SUBJECT: ISSUANCE OF AMENDMENT NO. 45 TO FACILITY OPERATING LICENSE
NPF-38 - WATERFORD STEAM ELECTRIC STATION, UNIT 3
(TAC NO. 69275)

AMENDMENT TO FACILITY OPERATING LICENSE

Amendment No. 45
License No. NPF-38

SAFETY EVALUATION BY THE OFFICE OF NUCLEAR REACTOR REGULATION
RELATED TO AMENDMENT NO. 45 TO
FACILITY OPERATING LICENSE NO. NPF-38
LOUISIANA POWER AND LIGHT COMPANY
WATERFORD STEAM ELECTRIC STATION, UNIT 3
DOCKET NO. 50-382

FIGURE 3.1-1

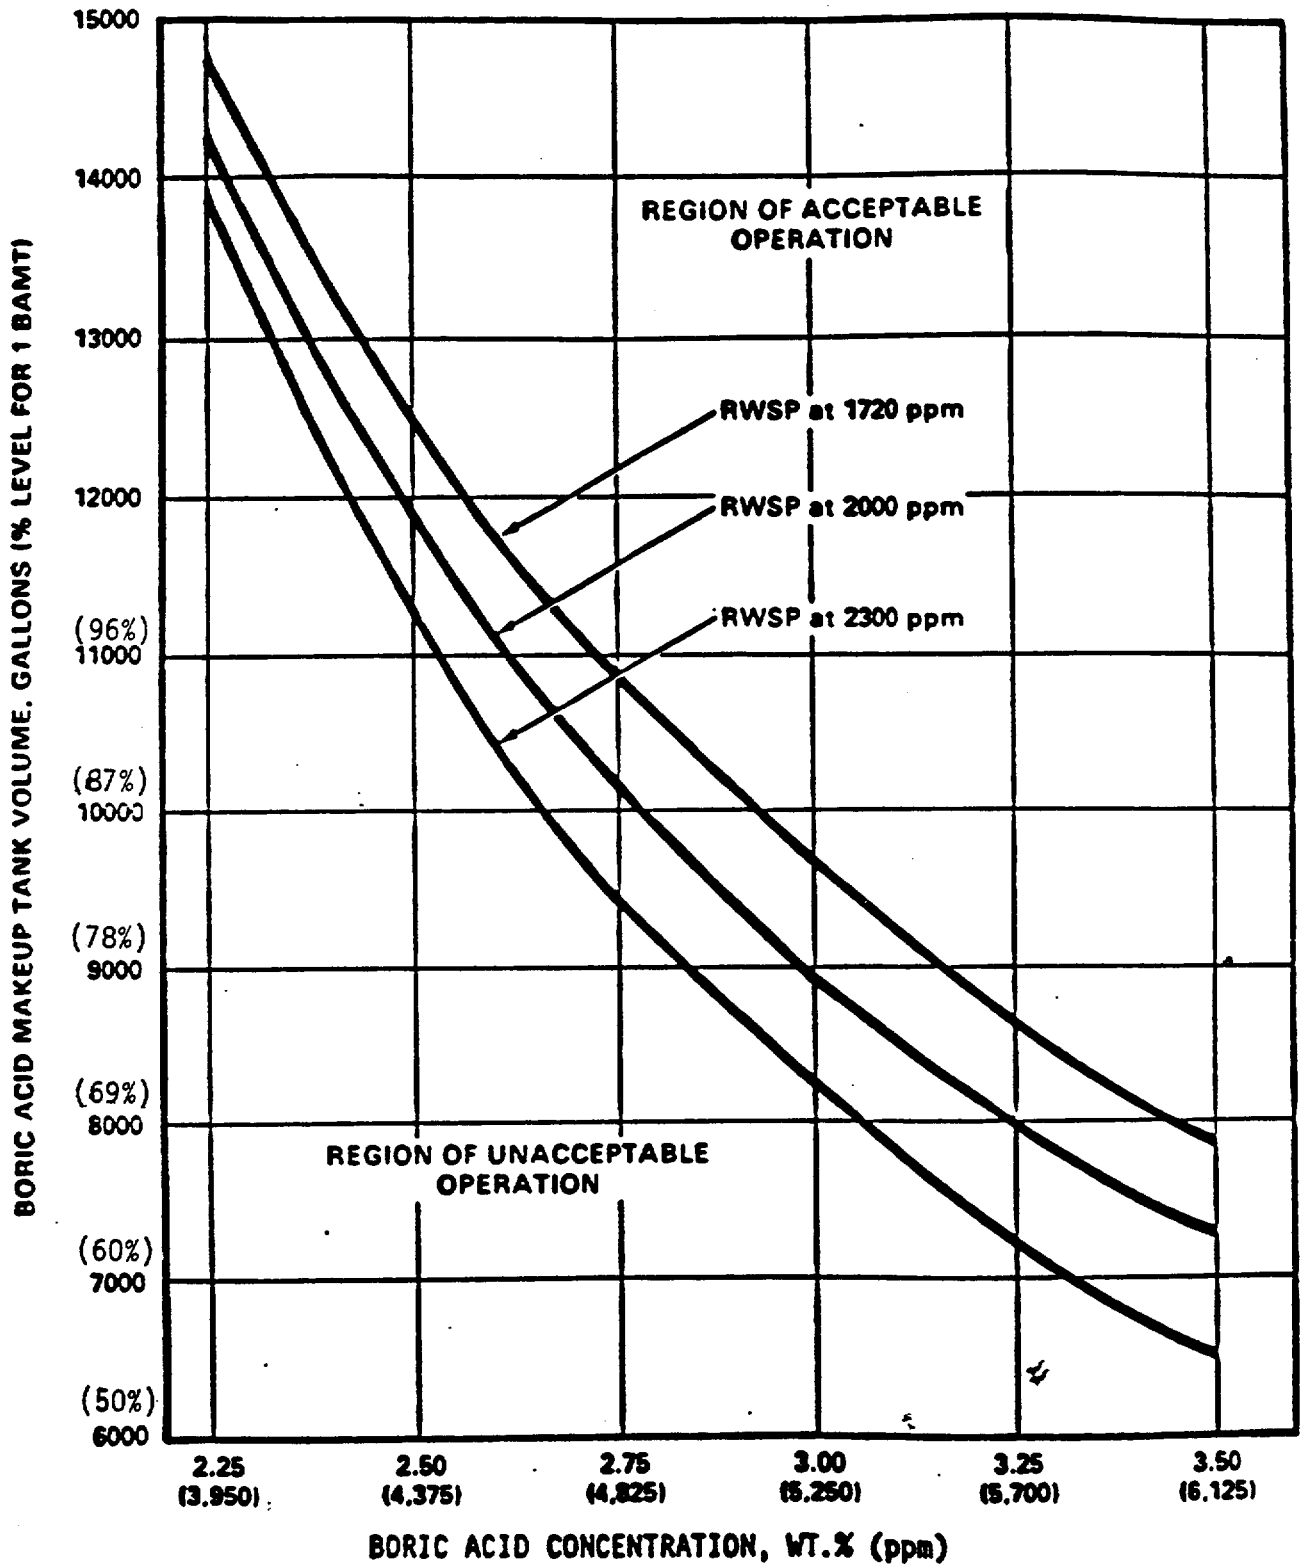
The amendment changes the Appendix A Technical Specifications by correcting the labels for percent level corresponding to Boric Acid Makeup Tank Volume on Technical Specification Figure 3.1-1, "Required Stored Boric Acid Volume as a Function of Concentration."

During a review, the licensee determined that the percent level labels on Figure 3.1-1 were inconsistent with the corresponding water volume. The volume labels included the entire quantity of water in the tank. Tank piping configuration reduced the actual available water volume.

The proposed change would correct the BAMT percent level labels on Figure 3.1-1.

The proposed change would correct the BAMT volume corresponding to percent volume on Technical Specification Figure 3.1-1. Analysis of the water required for analyzed accidents remains conservative and therefore acceptable.
